## 工程指示 / 要求簡箋(E.I.)

工程指示編號：EI / 3066 / 21

工程編號：J - 852

工程名稱：亞皆老街中電

本品  
4103

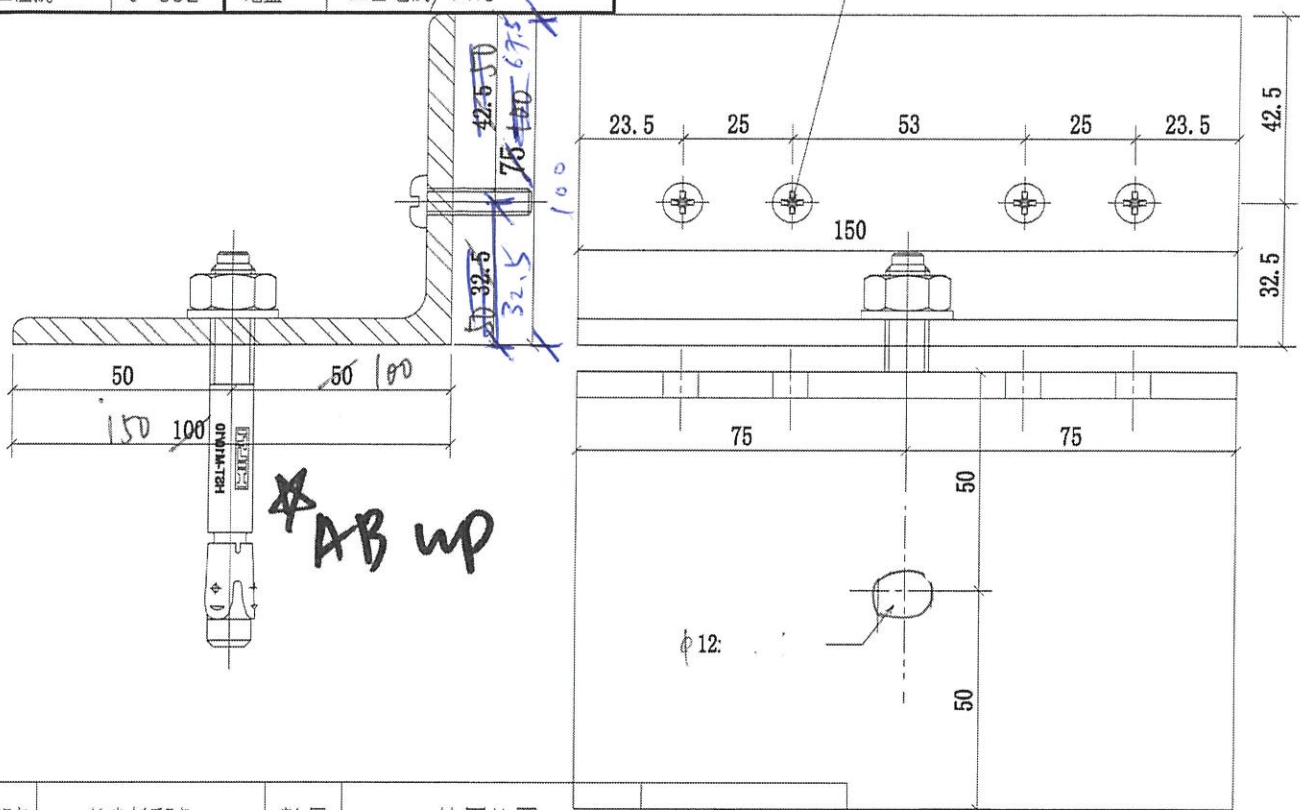
A 版：改寫材料 150x100x10mm 厚。

序號	物料編號	數量	使用位置	樓層
01	4103-MS01-Y9	45	J852-SD-ALC-4103	T1/(1~21F)
02	4104-MS01-Y9	45	J852-SD-ALC-4104	T1/(1~21F)
03	4105-MS01-Y9	<del>102</del>	J852-SD-ALC-4105	T1/(1~23F)
04	4106-MS01-Y9	<del>90</del>	J852-SD-ALC-4106	T1/(1~21F)
05	4107-MS01-Y9	<del>12</del>	J852-SD-ALC-4107	T1/(22,23F)
06	4203-MS01-Y9	48	J852-SD-ALC-4203	T2/(1~22F)
07	4204-MS01-Y9	48	J852-SD-ALC-4204	T2/(1~22F)
08	4205-MS01-Y9	<del>102</del>	J852-SD-ALC-4205	T2/(1~23F)
09	4206-MS01-Y9	<del>90</del>	J852-SD-ALC-4206	T2/(1~21F)
10	4207-MS01-Y9	<del>12</del>	J852-SD-ALC-4207	T2/(22,23F)
11	4304-MS01-Y9	45	J852-SD-ALC-4304	T3/(1F~21F)
12	4305-MS01-Y9	45	J852-SD-ALC-4305	T3/(1F~21F)
13	4306-MS01-Y9	<del>102</del>	J852-SD-ALC-4306	T3/(1~23F)
14	4307-MS01-Y9	<del>8</del>	J852-SD-ALC-4307	T3/(1F)
15	4307A-MS01-Y9	<del>96</del>	J852-SD-ALC-4307A	T3/(2~23F)
		888	276
